Project Name: Comfort Care White Lake
 Description: Rezoning & Preliminary Site Plan Approval
 Date on Agenda this packet pertains to: January 20th, 2022

RE: Comfort Care Assisted Living- Preliminary Site Plan Review – 2nd Review

RE: Comfort Care
Rezoning and Preliminary Site Plan – Review #2

PROJECT NUMBER	210303	SHEET	C200
PROJECT PHASE	SPA

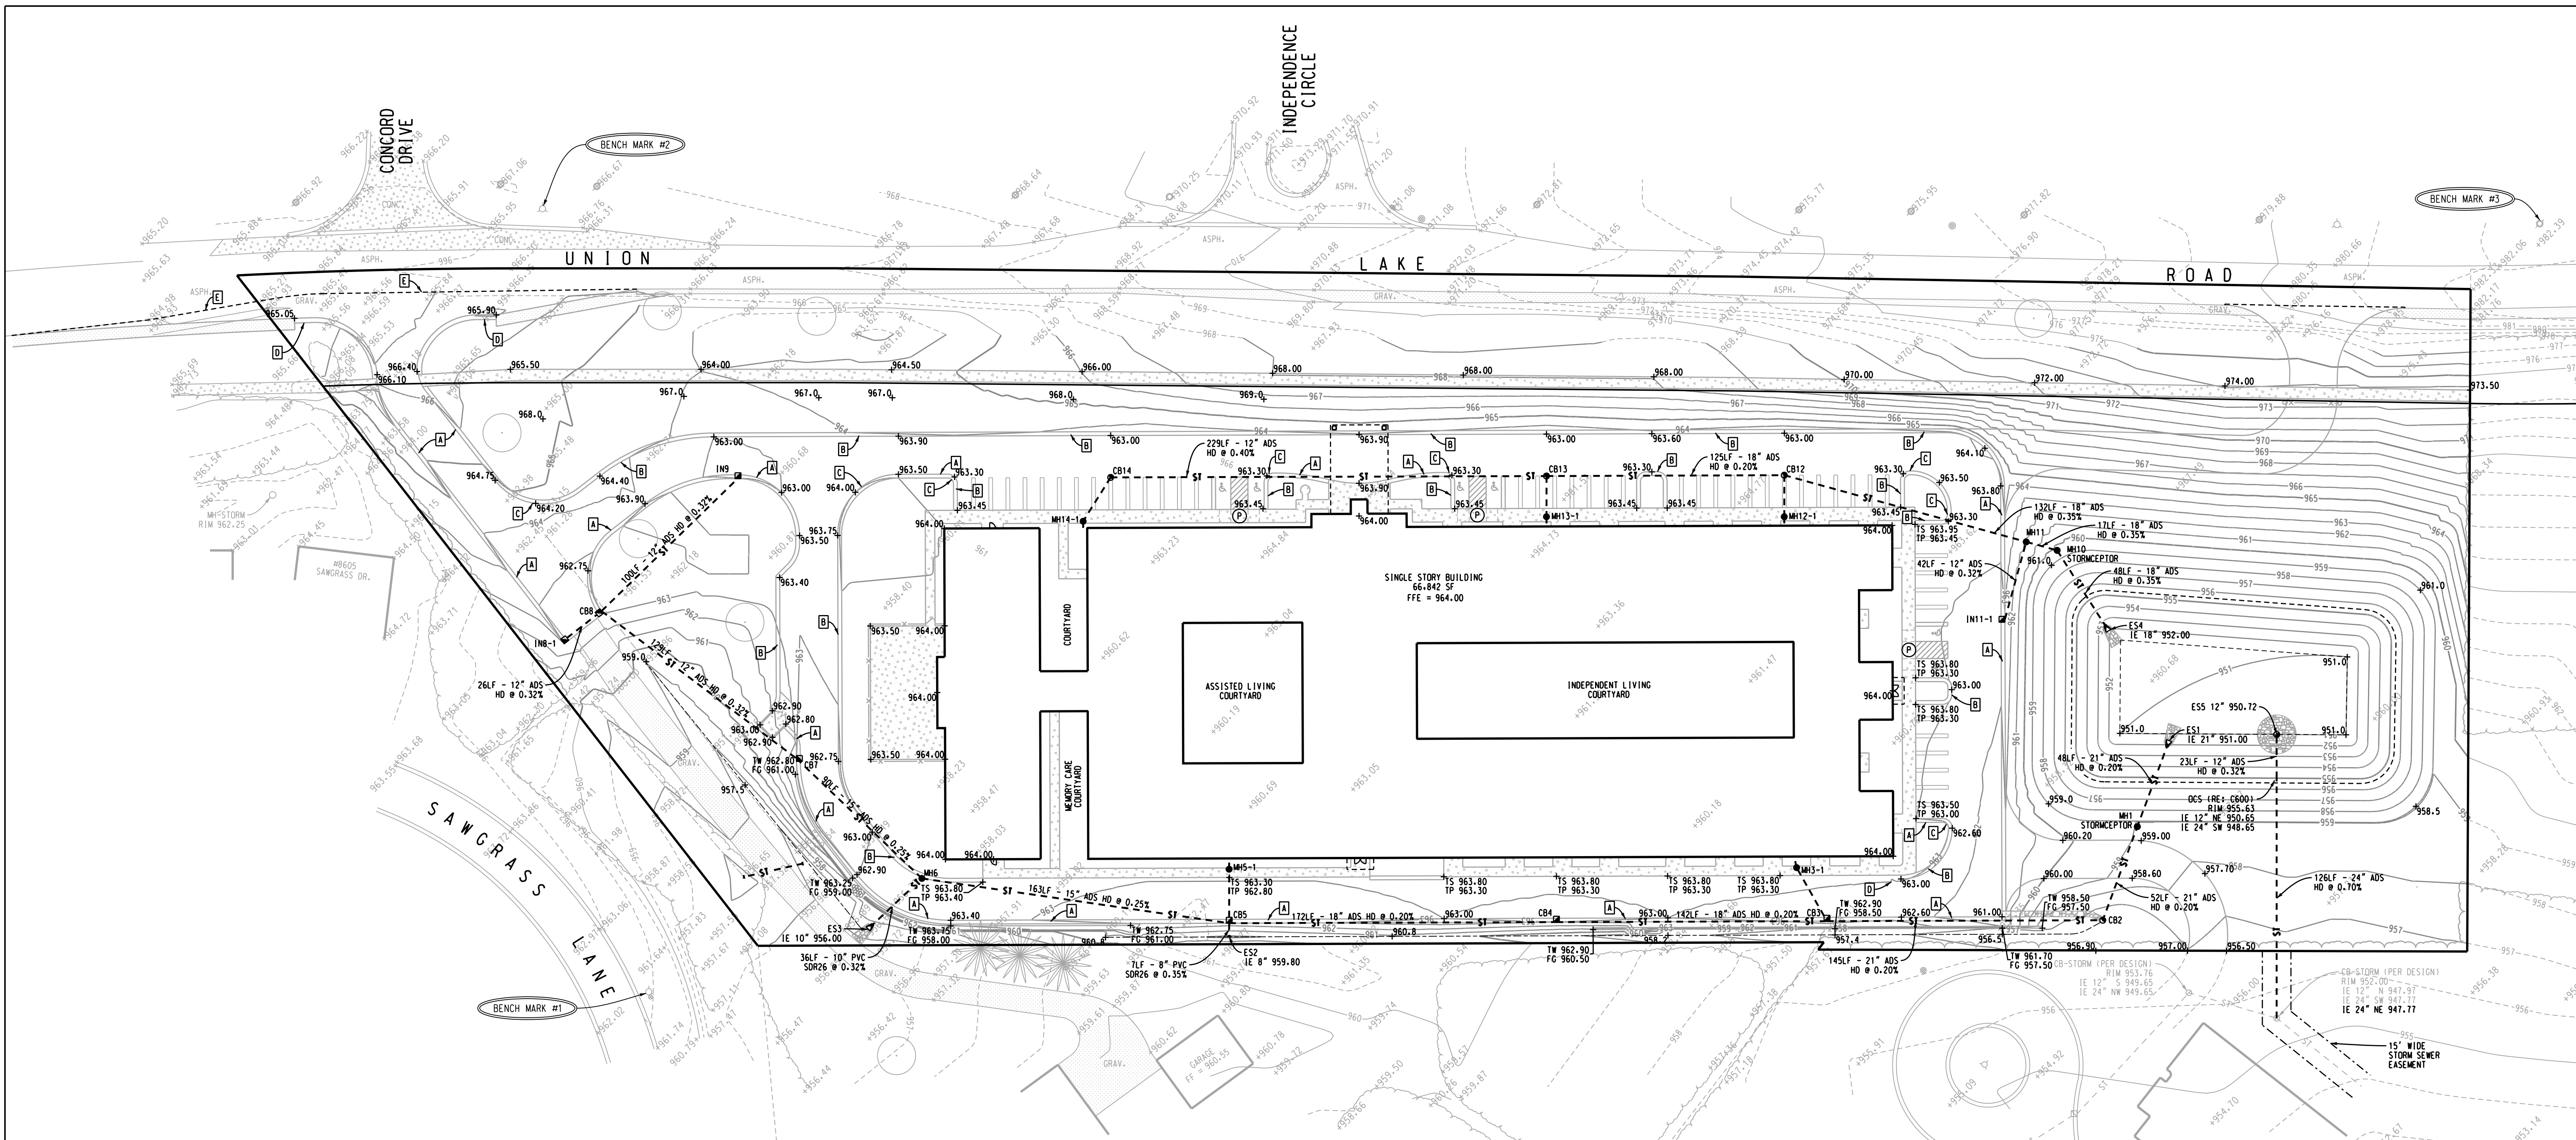
Comfort Care has requested rezoning to PD (Planned Development) and preliminary site plan approval to construct an independent living, assisted living, and memory care facility at Parcel Number 12-36-176-002 **(the parcel number shall be provided on the site plan), (comment outstanding)** located on the west side of Union Lake Road, south of Preserve at Hidden Lake. The approximate 8.37-acre (gross area; **the net area of the site shall be listed on the plans**) **(comment outstanding)** site is zoned LB (Local Business) and contains over 800 feet of frontage on Union Lake Road **(the recorded property description varies from the measured property description. The Township Engineering Consultant shall review the legal description of the parcel. Additionally, the dimensions of the parcel shall be labeled on the site plan).** **(Comment outstanding. Contrary to a statement in the response letter provided to the first review, the parcel dimensions are not labeled on Sheet C200).**

PROJECT NUMBER	210303	SHEET	C401
PROJECT PHASE	SPA

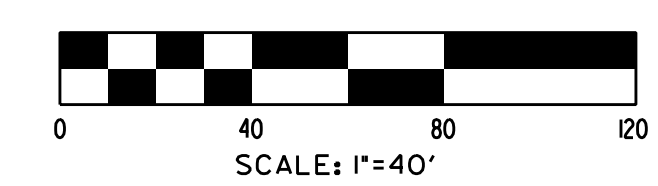
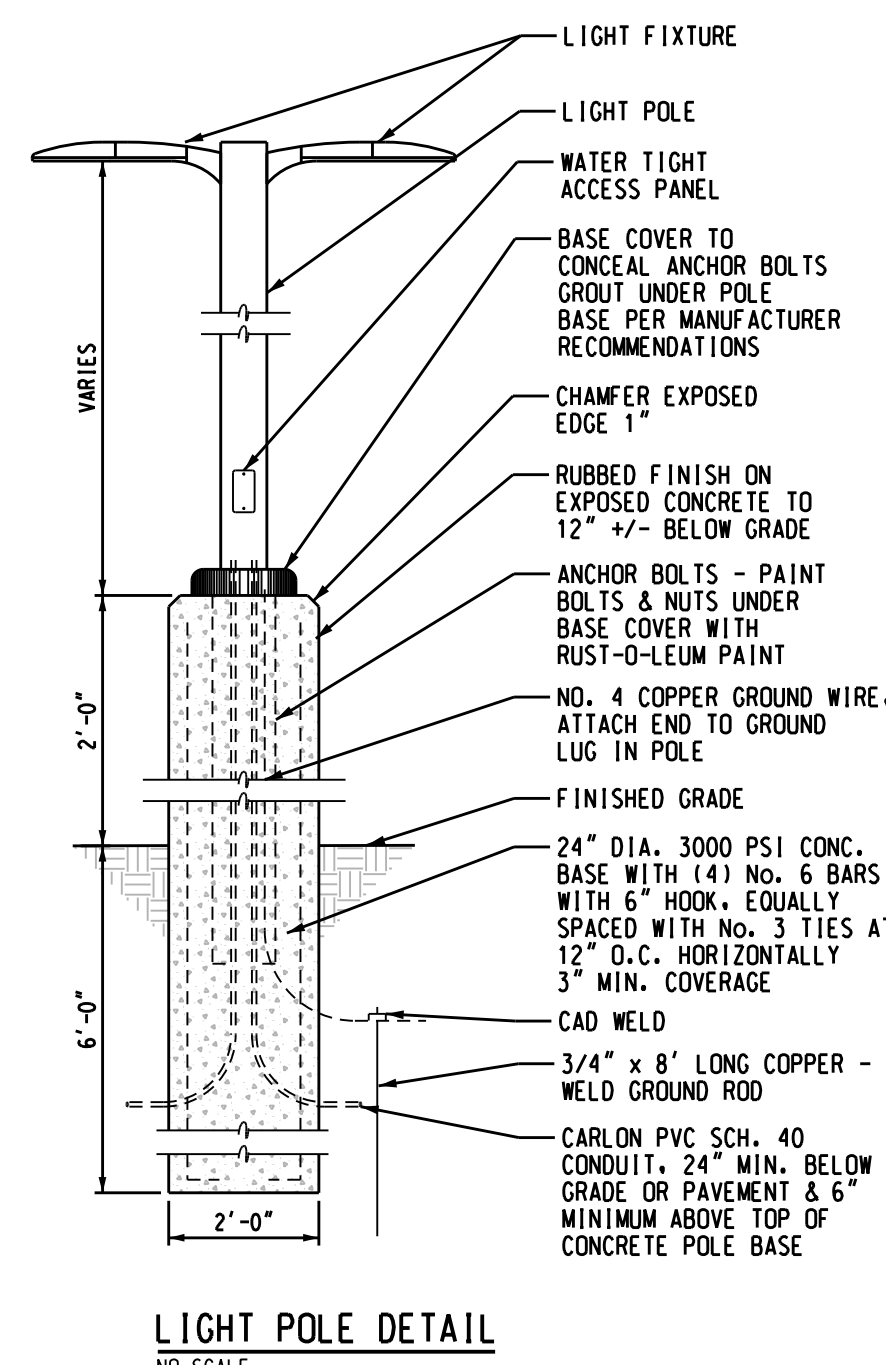
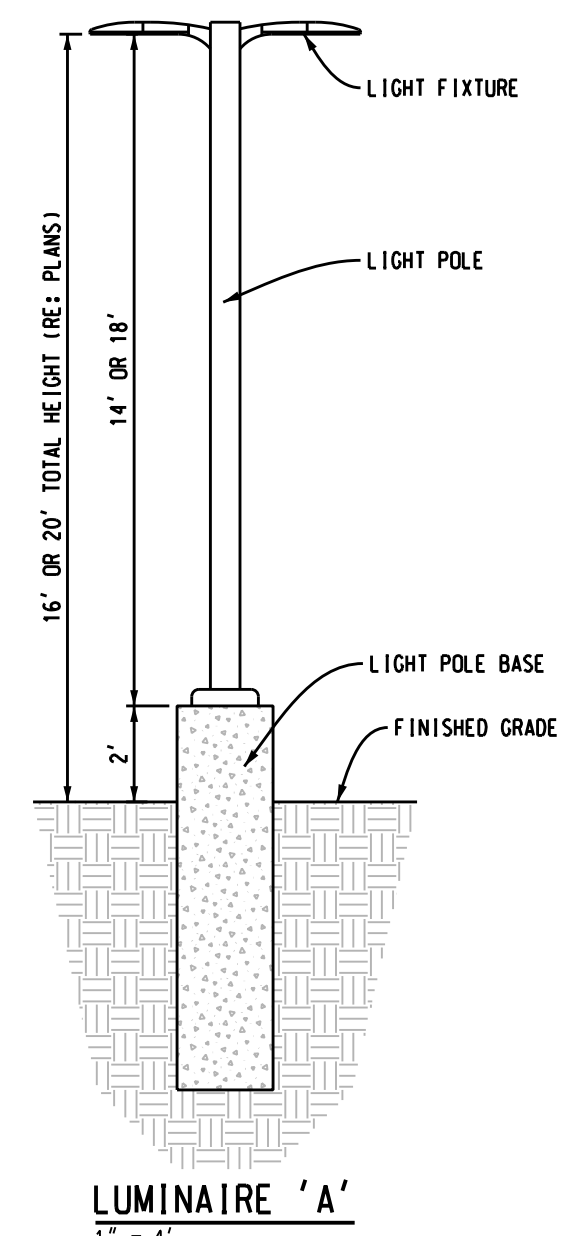
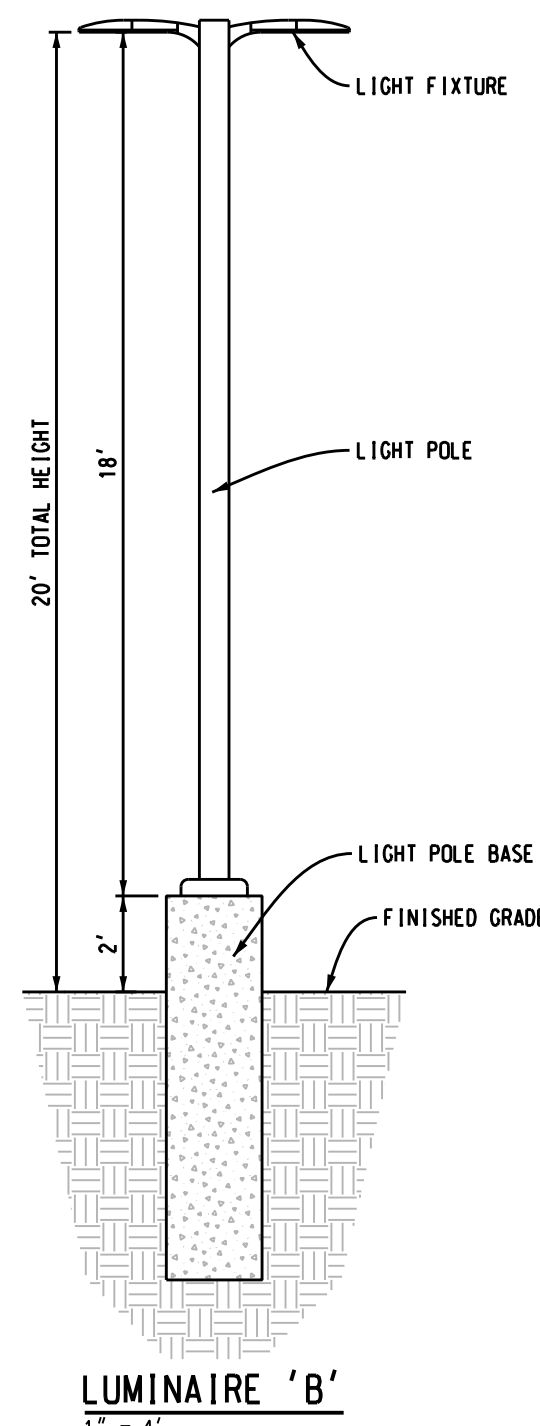
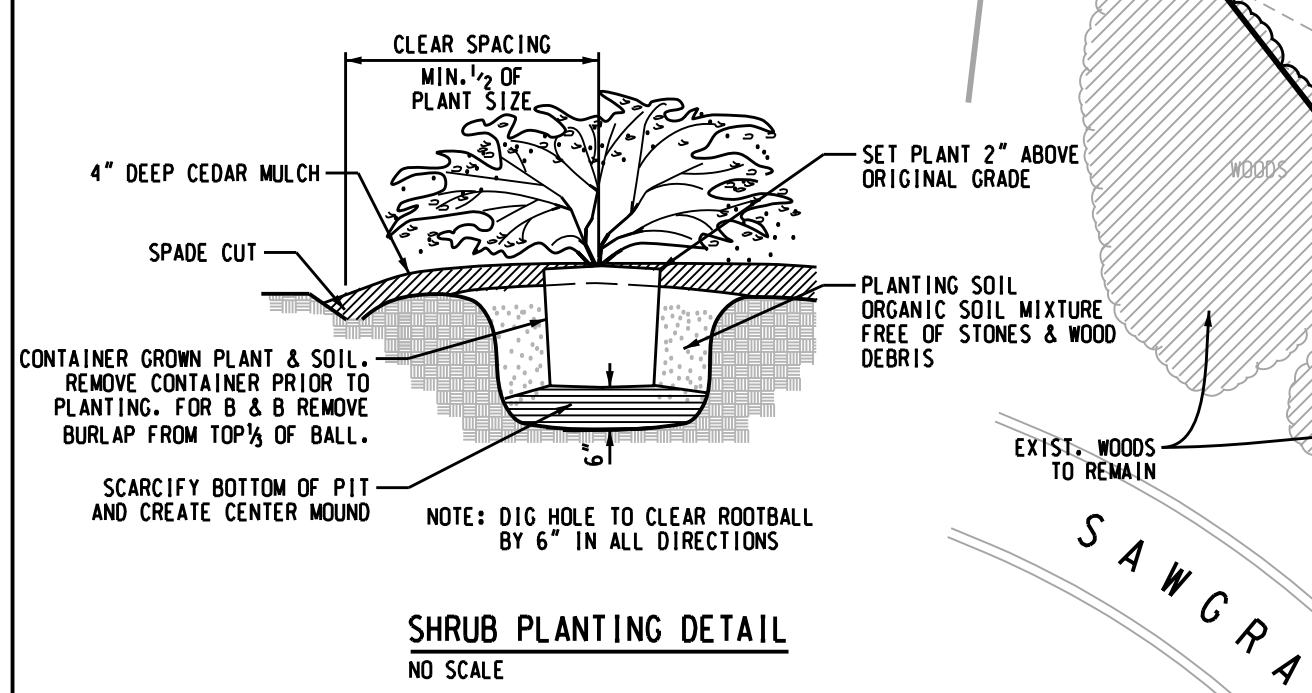
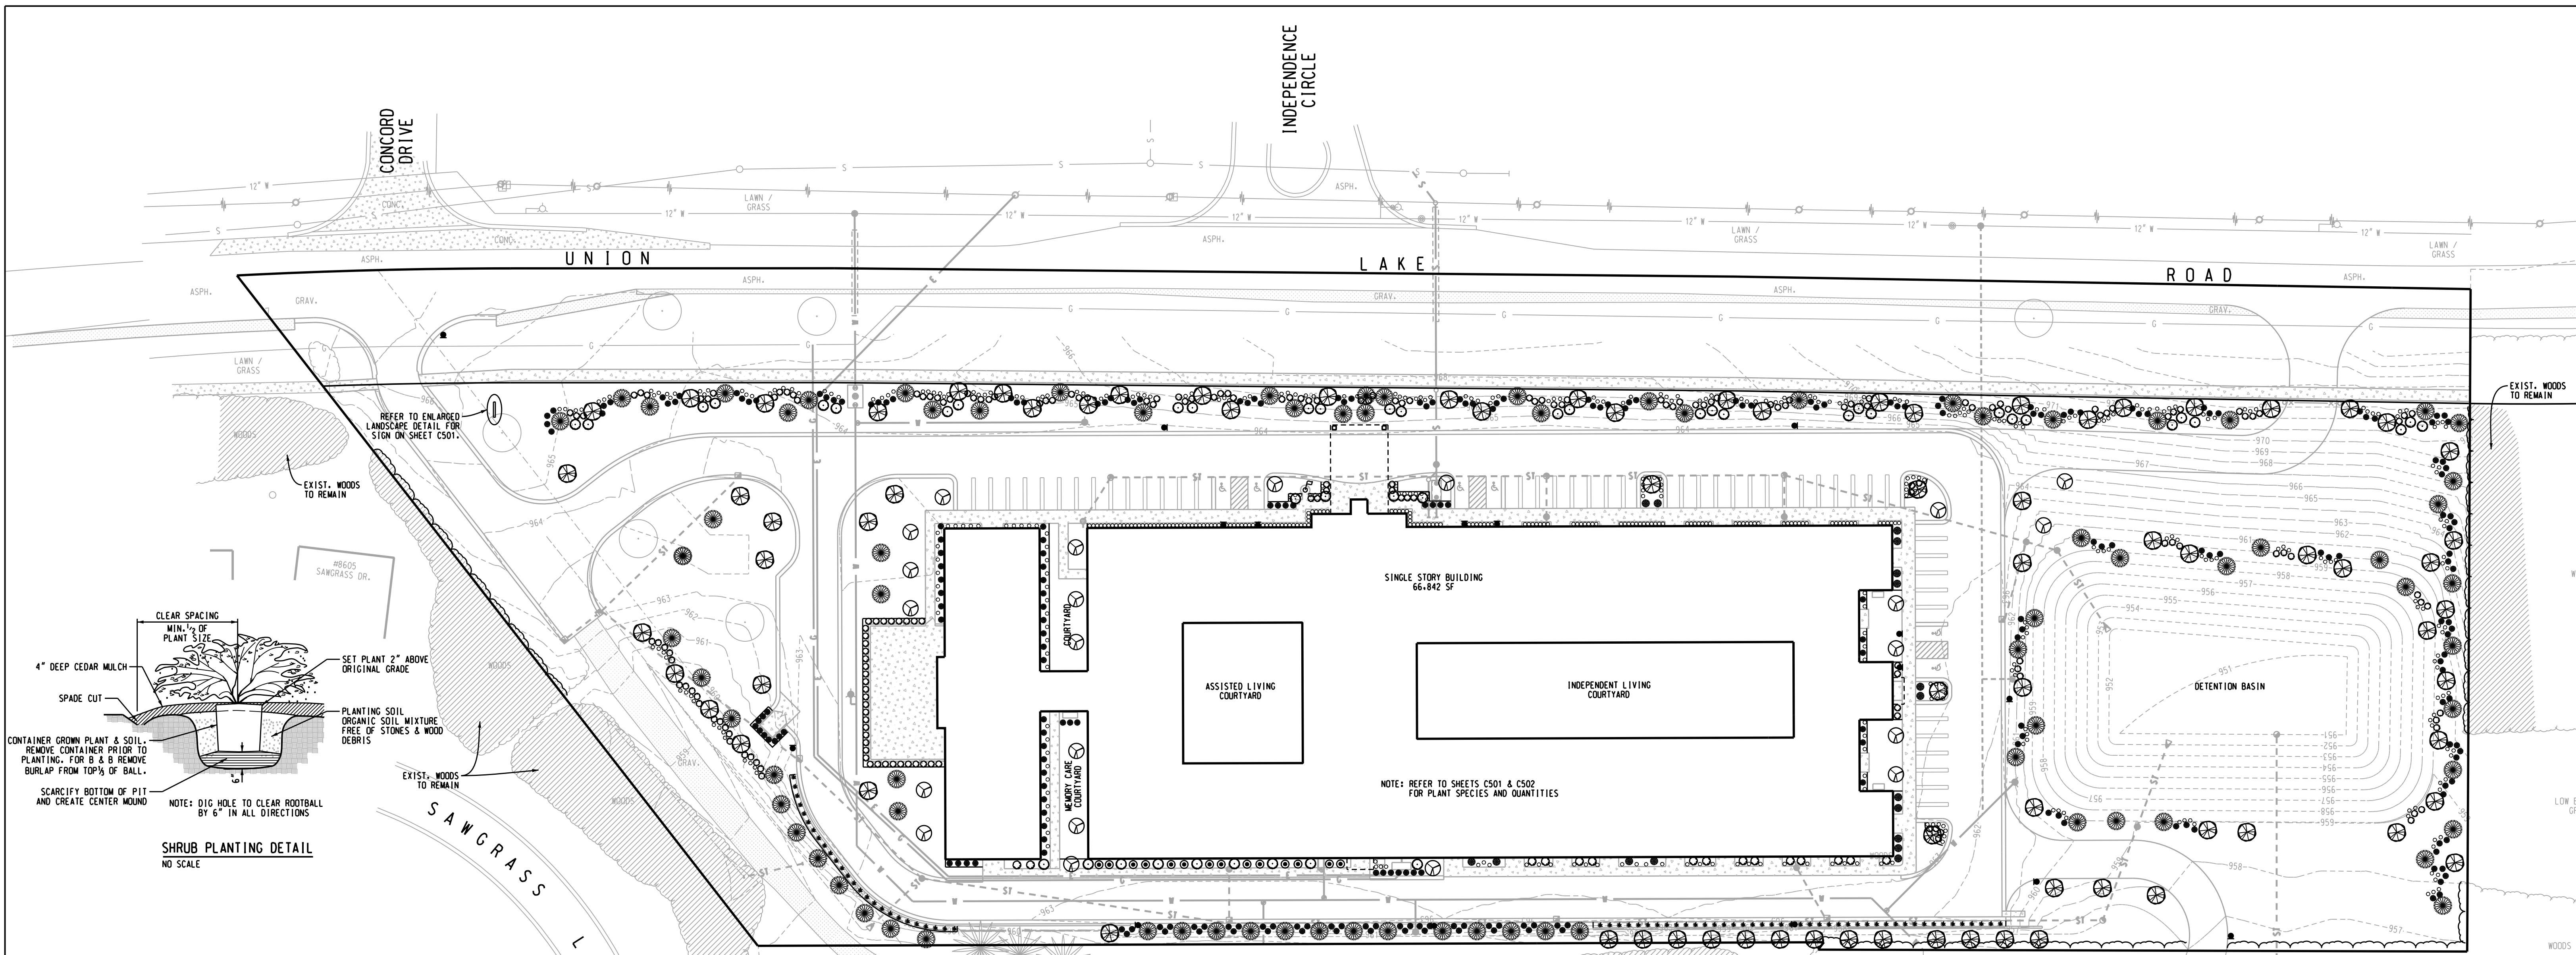
- **Complete catalog details (lighting fixture specification sheets) for all proposed fixtures shall be provided.** (Comment addressed. However, the proposed Lightway wall-mounted fixture is not permissible. The zoning ordinance states floodlights, wall pack units, and other types of unshielded lights, and lights where the lens or bulb is visible outside of the light fixture are not permitted. The intent is wall-mounted decorative or architectural lighting must be fully shielded and directed downward – up-lighting or outward shining lighting are not permitted. The conceptual exterior elevations and photometric plan shall be revised to eliminate the Lightway fixtures).

- No wall-mounted decorative or architectural lighting is proposed on the building. **(Wall-mounted lighting is now proposed).**
- Parking lot luminaries shall not exceed 16 feet in height within 25 feet of a lot line. **The two northern luminaries are within 25 feet of the lot line and shall be relocated, or a waiver requested.** (Comment addressed. Per the revised plans, the two aforementioned luminaries would not exceed 16 feet in height).

- **The light pole detail indicating height is inconsistent with the height labeled on the plan. Revise accordingly to provide the total height, including the base, pole, and light fixture.** (Comment addressed. The light pole details correlate with the proposed heights labeled on the plan).

- **A separate light pole detail, drawn to scale, shall be provided for Luminaire “A” and Luminaire “B.”** The provided light pole detail may represent the type “B” luminaire. (Comment addressed. Separate light pole details were provided for Luminaire ‘A’ and Luminaire ‘B’).

- **The light pole detail does not represent the fixture depicted on the provided partial catalog detail. For reference, the fixture is the assembly holding a lamp (bulb). Revise accordingly.** (Comment addressed. Fixtures on the light pole detail are consistent with the lighting fixture specification sheets).

- **The Luminaire Schedule shall be revised; both luminaries are labeled “A” and the plan shows a type “B” luminaire.** (Comment addressed. The Luminaire Schedule was revised accordingly).

OUTLET CONTROL STRUCTURE #2 (SOUTH POND)
NO SCALE

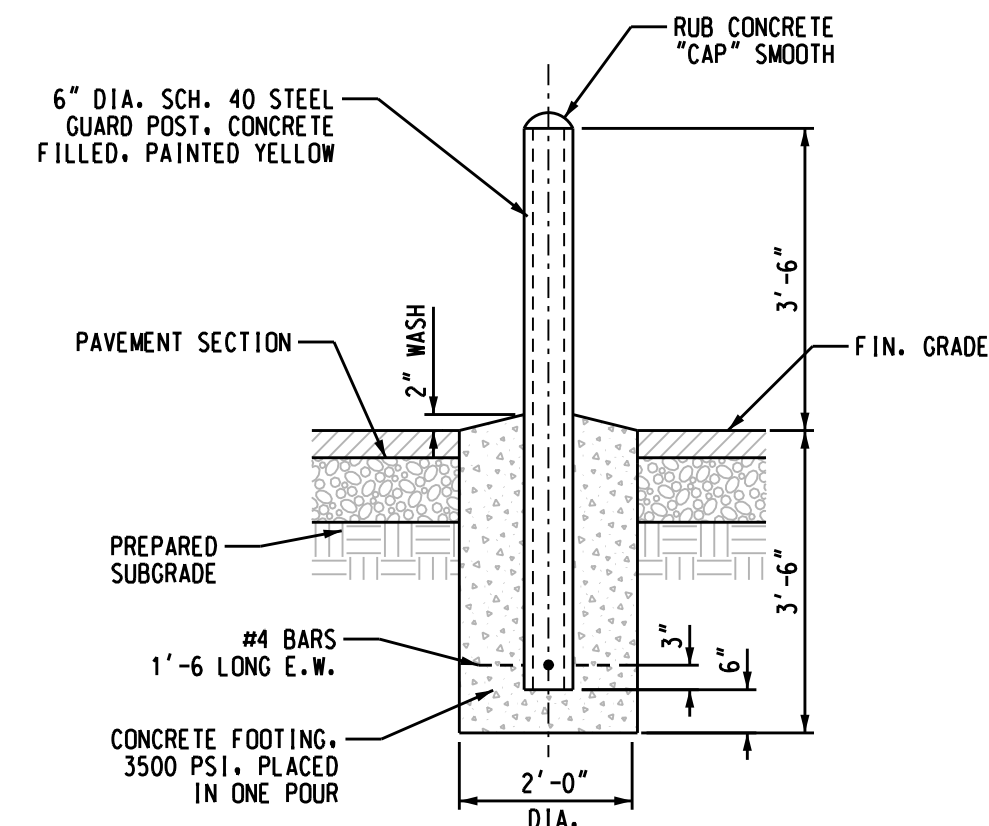
1. MH6 will need to be moved such that there is a minimum of 10' of horizontal separation between it and the proposed building. **Comment addressed.**
 2. The design engineer will need to demonstrate that the proposed storm sewer material (ADS HD) will maintain its integrity when located under proposed pavement, otherwise use CLIV Reinforced Concrete pipe within pavement influence. **Comment outstanding.**
 3. Sheet C300 – Site Grading Plan indicates a 15' wide storm sewer easement for West Valley; easement width is 12'. **Comment outstanding.**
 4. Clarify on the Soil Erosion Plan as to why the OCS structure in the basin is to be temporary. **Comment outstanding.**
 5. Clarify reference to South Pond on OCS#2 detail on Site Details sheet. **Comment outstanding.**
-
